## **IMPORTANT SAFETY RECALL – SN601**

**Safety Recall Number 13V-096**

**TEREX Utilities****SAFETY NOTICE****SN-601-13**

SUBJECT: 15 Port Collector used on Aerials

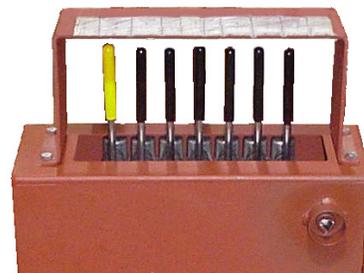
TEREX Utilities has received reports of a seal land on the 15 port hydraulic rotary manifold failing after several years of operation, when operating the Aerial Device. The failure of a seal land will allow oil to flow to the adjacent port and may pressurize that function causing movement. **If fluid pressurizes an adjacent port it can result in unexpected movement of the boom and platform.**

This bulletin only applies to Aerial Devices with lower controls located below rotation which utilize the 15 port collector, P/N 72889 or 494311. The owner or user must immediately perform the following test of the unit.

Each unit will be evaluated by Terex Utilities and the hydraulic ports in the collector adjusted depending on the configuration and options by each serial number.
